REMARKS

Drawings

FIG. 1

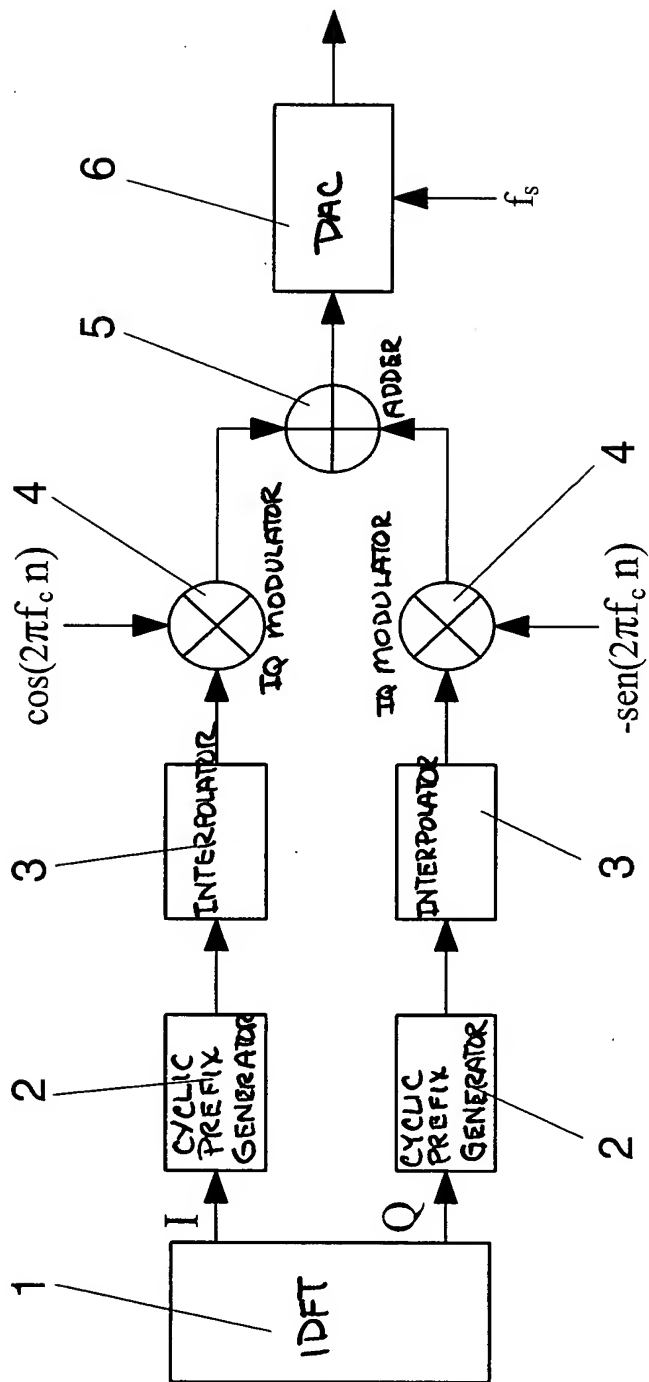
The Examiner has objected to the drawings and particular, to figures 1, 2, 3 and 7 on the basis that labels for certain of the elements are not present. Applicants have prepared corrected drawings which are submitted herewith as four (4) sheets labeled "REPLACEMENT SHEET" and have also submitted a corresponding set of marked-up copies of the said drawings, reflecting the originally presented drawings having markings thereon to include the labels requested by the Examiner. Both sets of sheets are enclosed herewith and it is believed that the enclosed sheets represent full and complete compliance
